172 Central Ave
Subject Property
Built 1883
“Italianate”
Level 1

Re: Structural Review
Private Residence at 172 Central Avenue
Our file No. 18-15-0142

Unsafe Building – Order to Make Safe

RE: 172 Central Ave Site Inspection

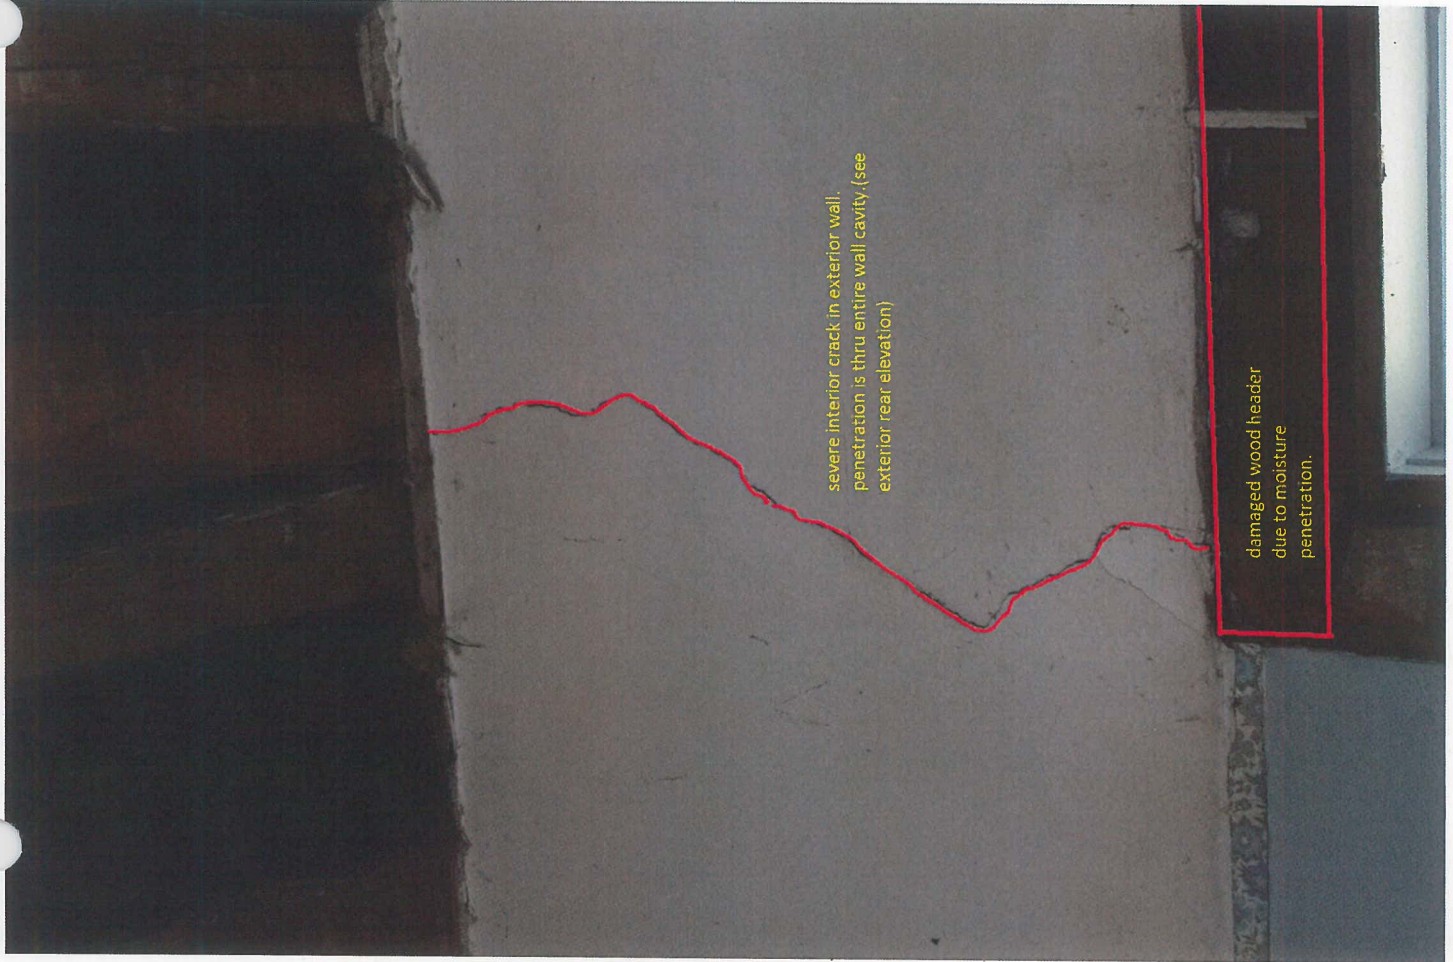
dry rot and decay of floor system. (not certifiable)

salvaged charred timber severely compromised due to notching. (not certifiable)

staining of floor joists indication of decay.

compromised joist due to opening cut in floor.

severe interior crack in exterior wall.
penetration is thru entire wall cavity. (see
exterior rear elevation)

damaged wood header
due to moisture
penetration.

main floor severe
masonry stress crack,
penetration thru entire
wall cavity (see rear
elevation)

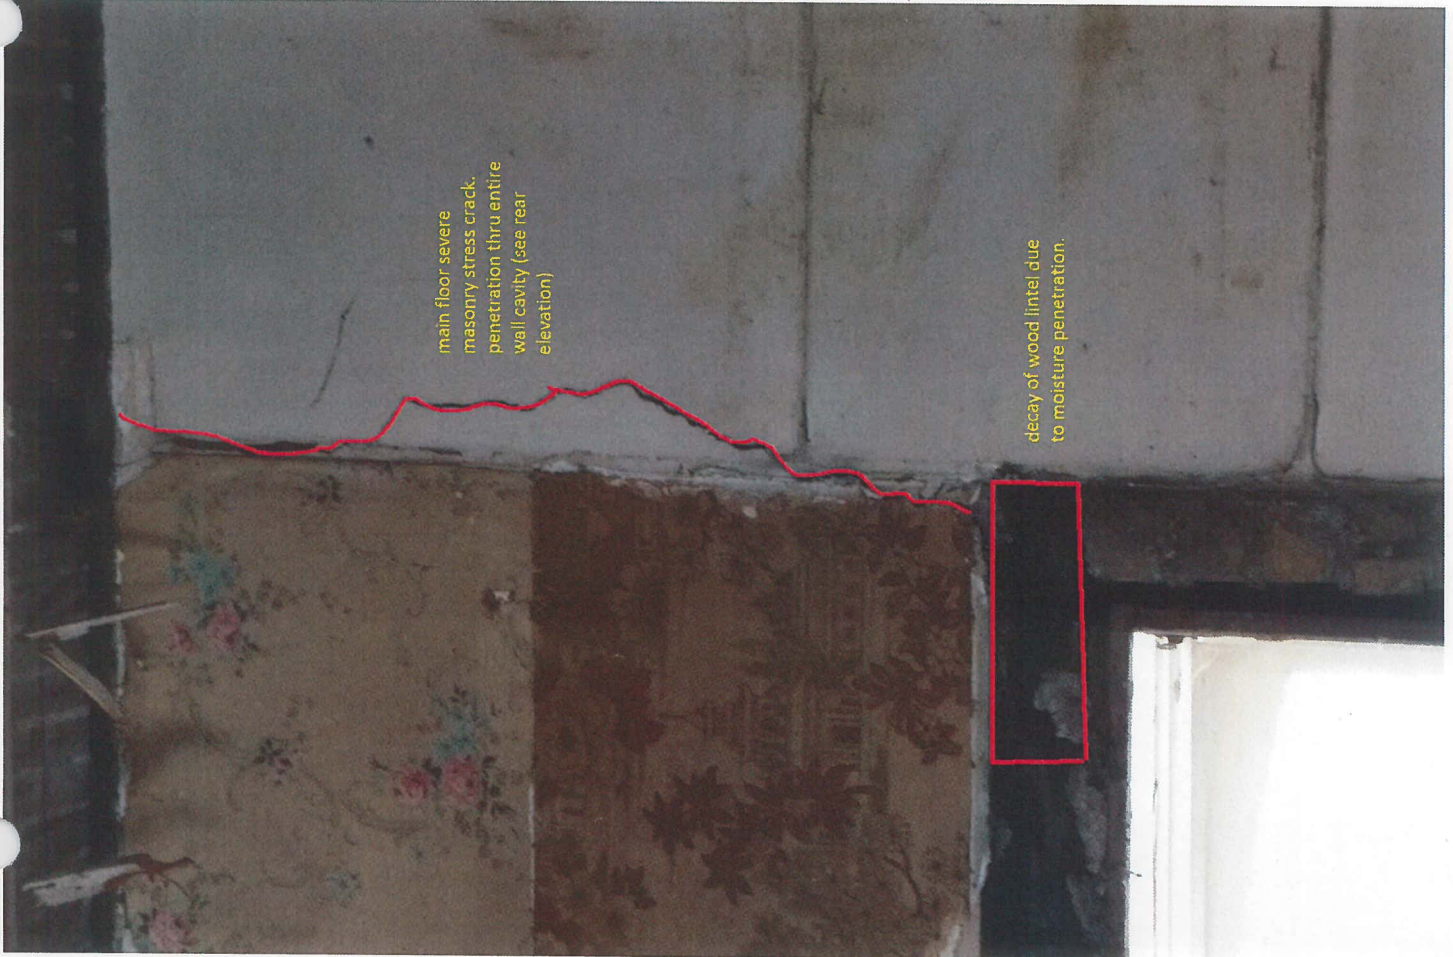
decay of wood lintel due
to moisture penetration.

beam compromised by
attic hatch opening.

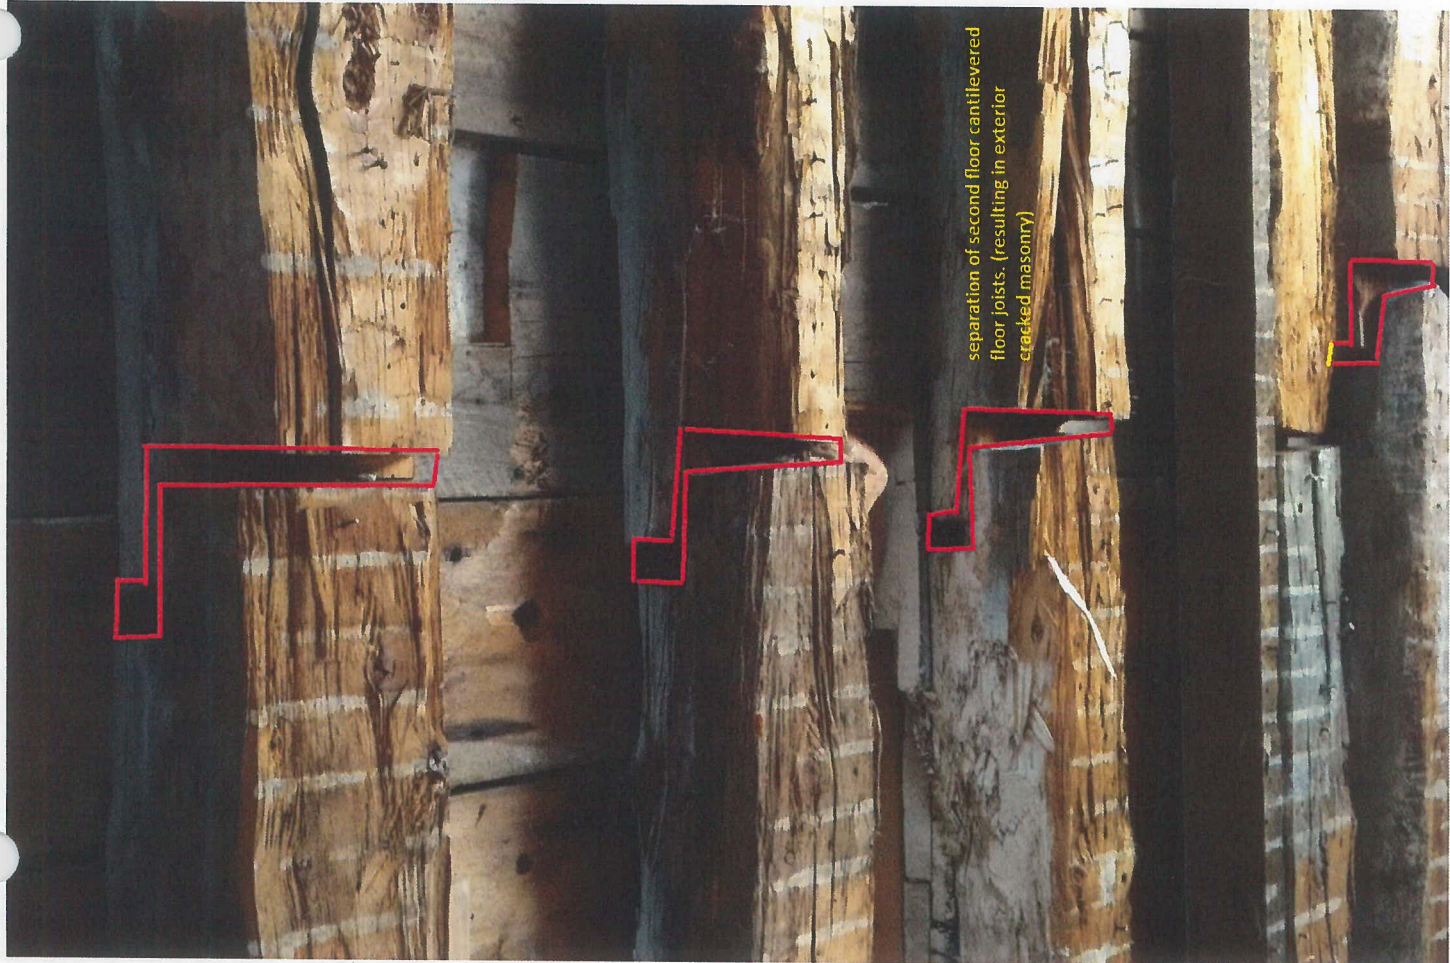
no connections at interior
or exterior walls. (friction
fit) allowing exterior to
thrust outward.

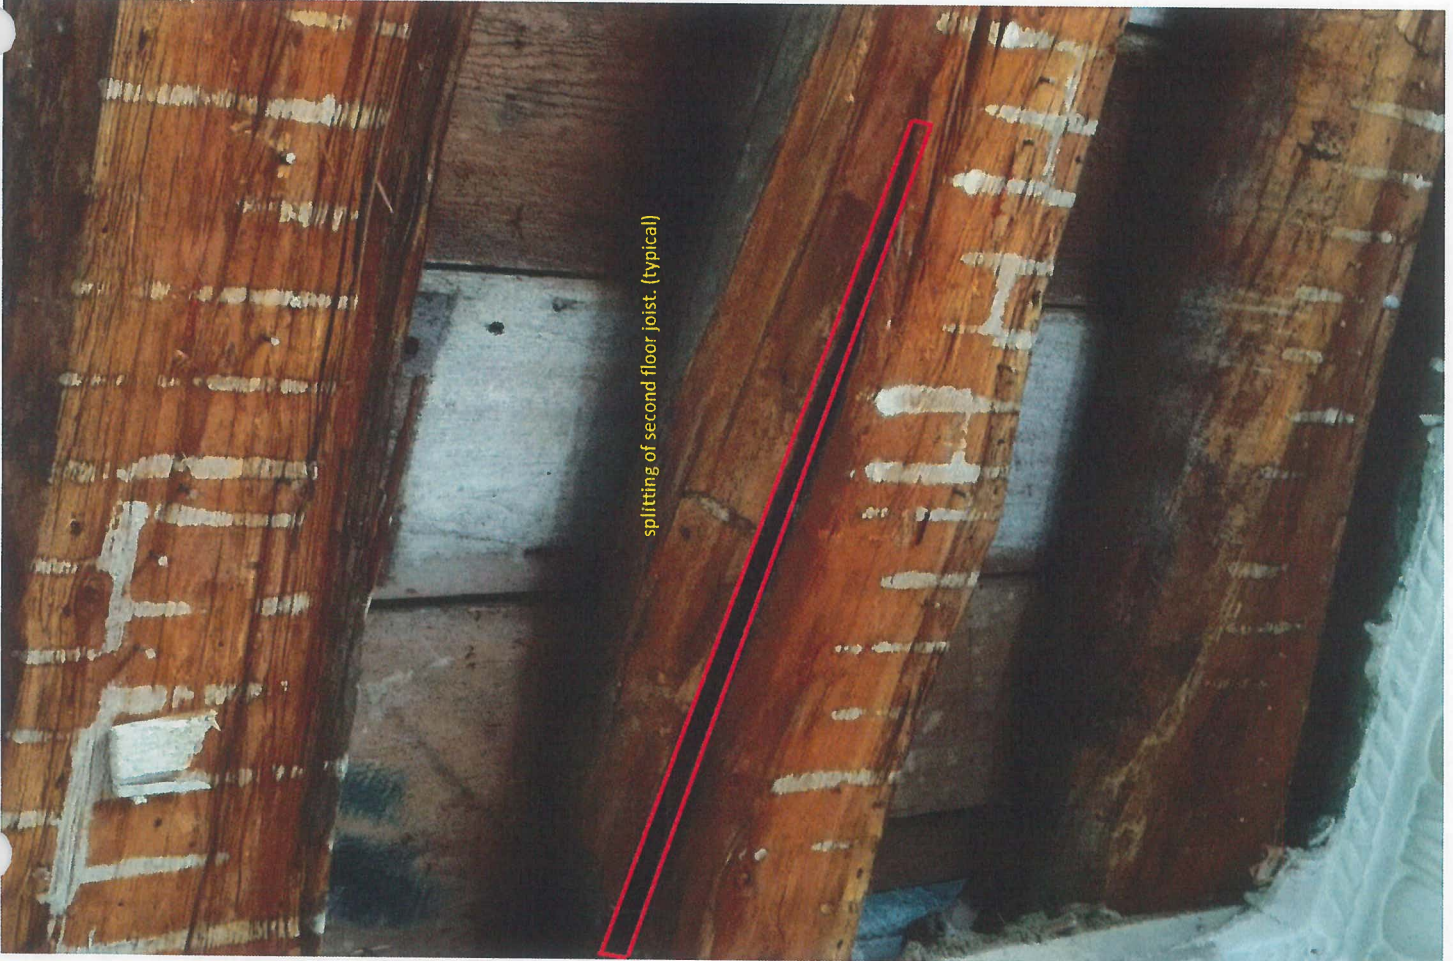
separation of second floor cantilevered floor joists. (resulting in exterior cracked masonry)

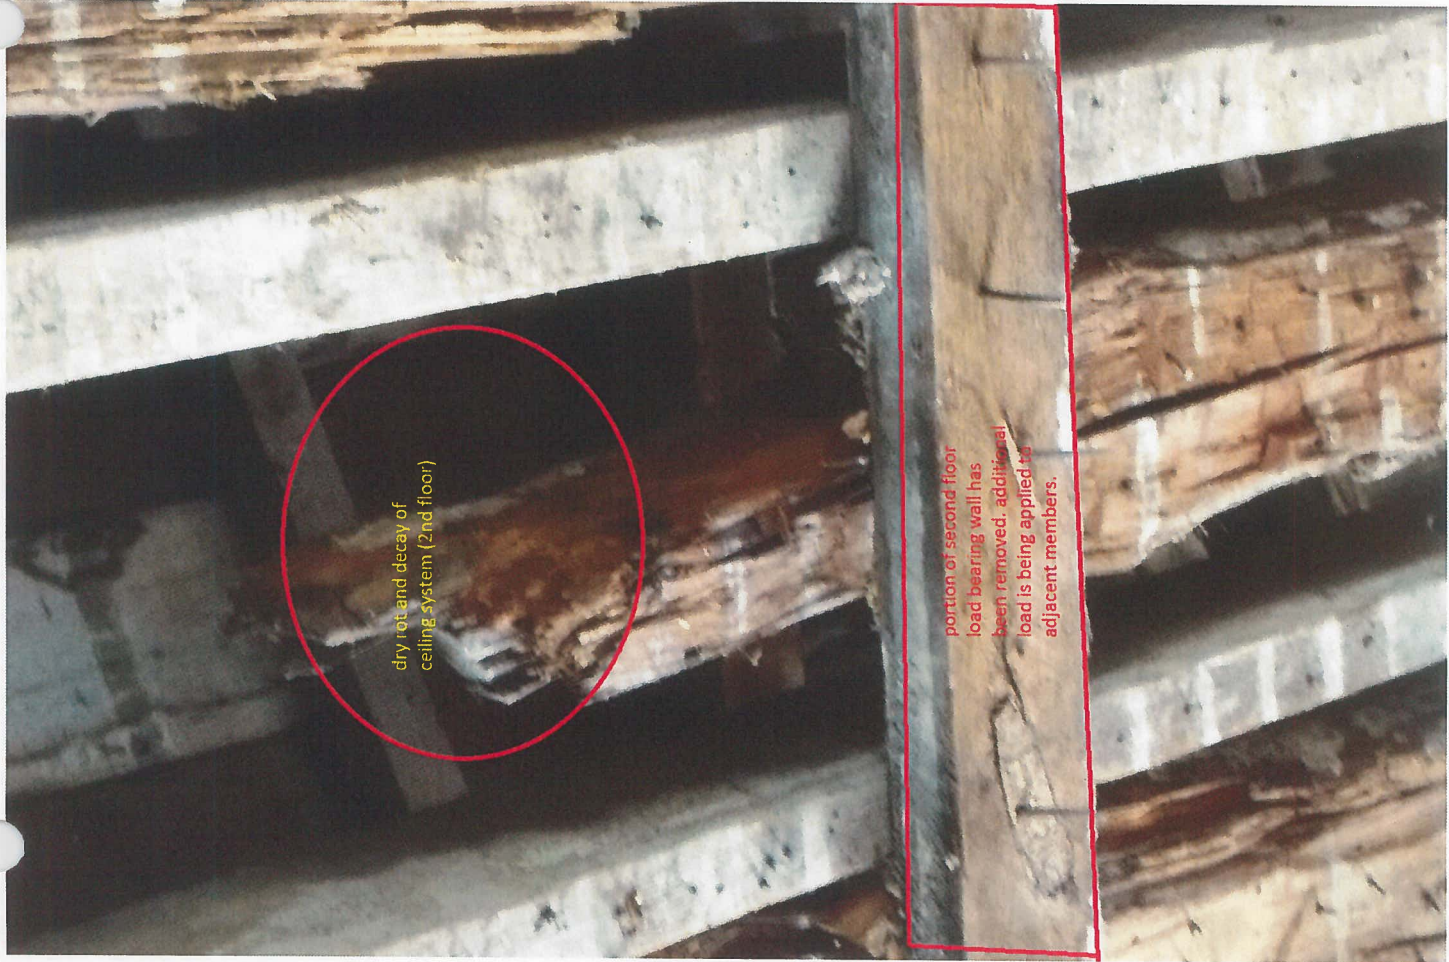
splitting of second floor joist. (typical)

dry rot and decay of ceiling system (2nd floor)

portion of second floor load bearing wall has been removed. additional load is being applied to adjacent members.

"friction fit" ceiling joists randomly configured with no connection to interior or exterior walls. (2nd floor)

load bearing wall members orientated in wrong direction. (load bearing capacity reduced)
